From: WILLIFORD Dennis (AREVA) [Dennis.Williford@areva.com]
Sent: Wednesday, July 13, 2011 1:48 PM
To: Tesfaye, Getachew
Cc: BENNETT Kathy (AREVA); DELANO Karen (AREVA); ROMINE Judy (AREVA); RYAN Tom (AREVA); Canova, Michael
Subject: Response to U.S. EPR Design Certification Application RAI No. 442, FSAR Ch. 7, Supplement 16
Attachments: RAI 442 Supplement 16 Response US EPR DC.pdf

**QUESTIONS for Instrumentation, Controls and Electrical Engineering 1
(AP1000/EPR Projects) (ICE1)**

Question 07.01-30:

Figure 7.7-6—Signal Flow from **PS** SCDS through CU

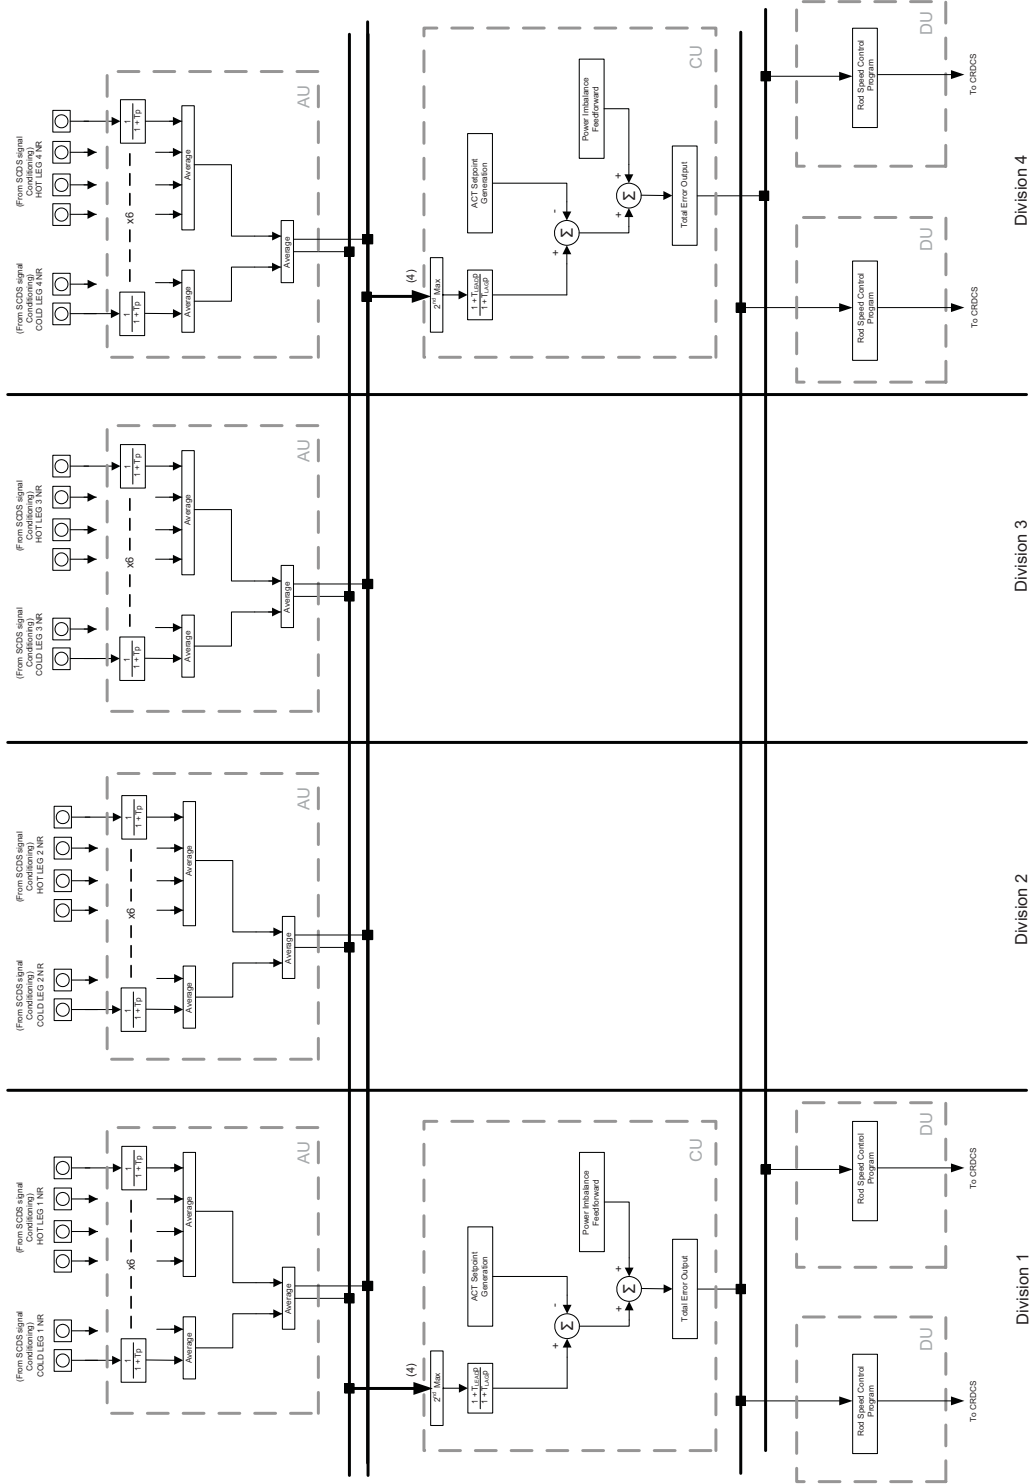
Provide details on how the U.S. EPR design will verify functionality of the self testing features based on guidance from BTP 7-17.

For the U.S. EPR design, the applicant has committed to meeting BTP 7-17, "Guidance on Self-Test and Surveillance Test Provisions." BTP 7-17 (which cites GDC 21 and 10 CFR 50.55a(h) as a regulatory bases) states that: "(a) Self-test functions should be verified during periodic functional tests, and (b) If automatic test features are credited with performing surveillance test functions, provisions should be made to confirm the execution of the automatic test during plant operation. The capability to periodically test and calibrate the automatic test equipment should also be provided. The balance of surveillance and test functions that are not performed by the automatic test feature should be performed manually to meet the intent of Regulatory Guide 1.118. In addition, the automatic test feature function should conform to the same requirements and considerations (e.g., test interval) as the manual function."

- a) The staff requests that the applicant provide details on the method by which the U.S. EPR Protection System self testing features will be periodically verified and how the operation will be confirmed during plant operation.
- b) How does the applicant propose to meet item (b), as quoted above?

Proposed changes to the instrumentation and controls (I&C) architecture were communicated to the NRC staff in the public meeting on February 15, 2011. The affected sections of U.S. EPR FSAR Tier 2, Sections 1.1, 1.2, 1.6, 1.7, 1.9, 3.2, 3.9, 3.10, 3.11, 4.4, 4.6, 5.4, 7.1, 7.2, 9.2, 14.2, 14.3, 15.0, 15.1, 15.4, 15.6, 16, 18.7, 19.1 were revised to incorporate modifications to I&C architecture and were included in the Response to RAI 442, Supplement 13 on June 3, 2011.

Additional conforming changes to U.S. EPR FSAR Tier 2 are provided with this response to address feedback from NRC staff.

U.S. EPR FSAR Tier 2, Sections 1.6, 4.6, 7.1, 7.2, 7.3, 7.4, 7.7, 7.8, 14.2, 18.7 and 19.1 will be revised as described in the response and indicated on the enclosed markup.
